VARIANCE APPLICATION

CITY OF GAHANNA, FRANKLIN COUNTY, OHIO NATIONAL CHURCH **RESIDENCES - GAHANNA** FINAL DEVELOPMENT PLAN

Below is the disposition of zoning comments for the National Church Residences Olde Ridenour Road Variance Application. Applicant's comments are provided in **bold**. Every comment not applicable to the Variance Application is excluded from this response

PLANNING AND DEVELOPMENT STAFF REPORT

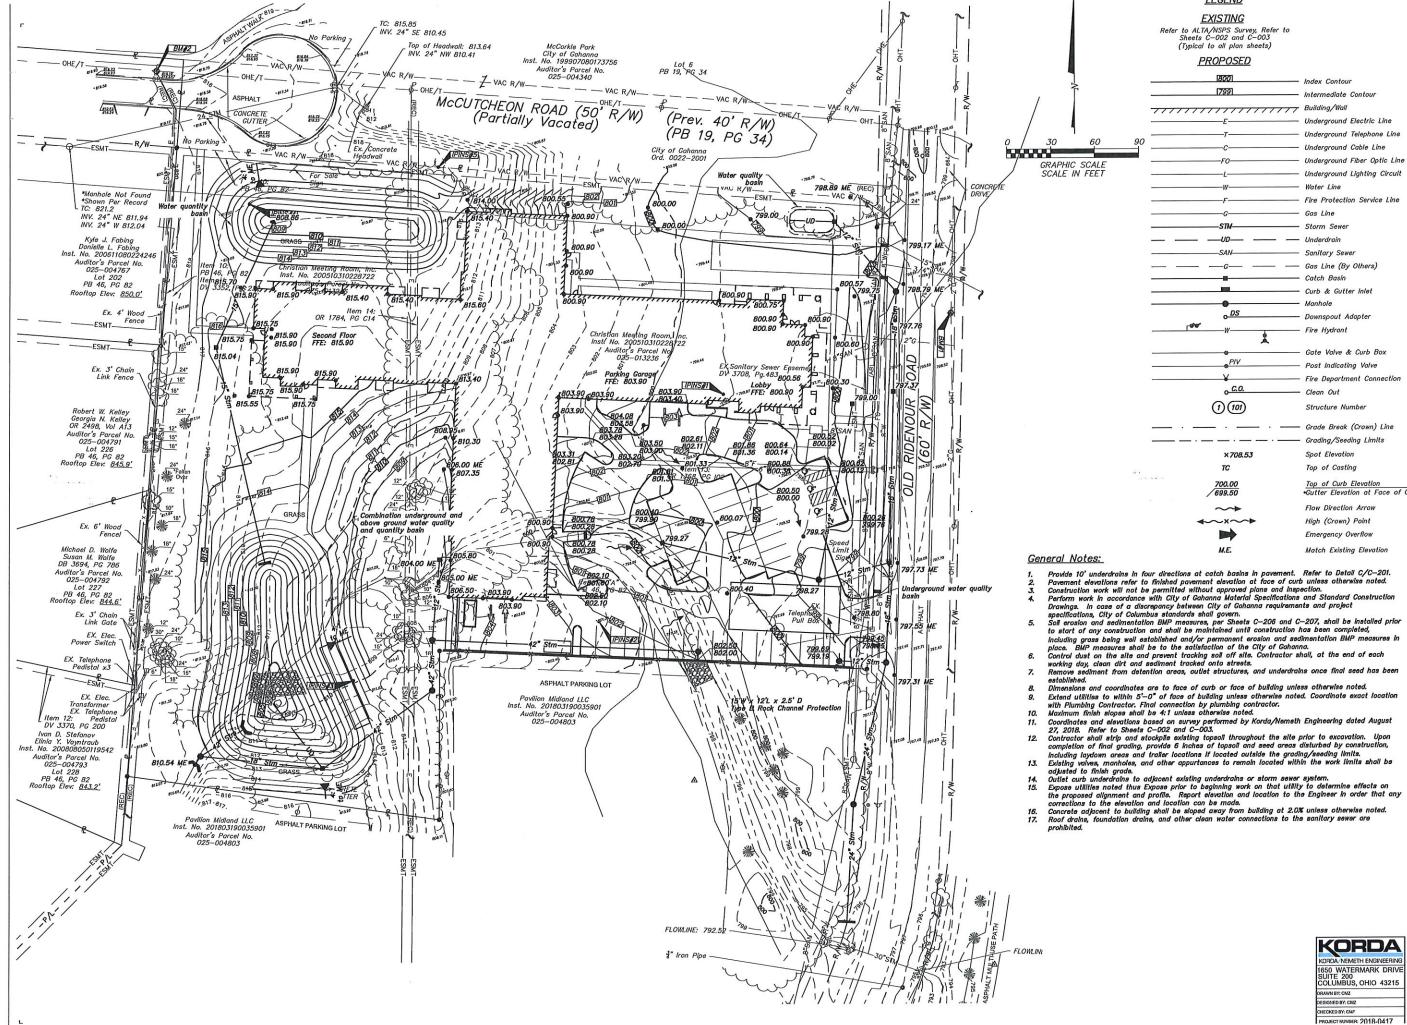
- 3/11/19 - The site plan (sheet C-100) depicts a 15' parking setback. Chapter 1167.15 requires a 25' parking setback. A revision to the plans or a variance will be necessary.

Response: The Applicant submits a revised statement of practical difficulty with this disposition letter. The revised statement of practical difficulty added a variance requesting
